G3 Reflash Process Change

Models Covered	Serial Number Or Year
Diesel Sterndrive JPS Models and Zeus	2016 to present

Mercury Outboard Service Bulletins	MerCruiser Service Bulletins
2016-11R4 July 2018	2017-05R1 July 2018
2016-12R4 July 2018

67491

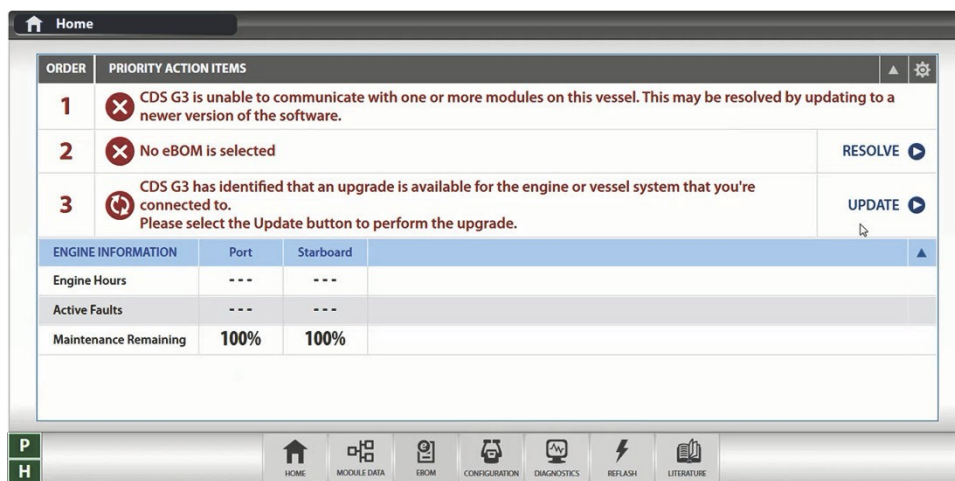
The G3 reflash process was refined to make the process easier for the technician. The new process is available in: G3 2018 update 9.

The technician will no longer need to contact Mercury Technical Service to obtain the vessel personality prior to beginning the reflash process. G3 will now record and rewrite the vessel personality during the reflash process.
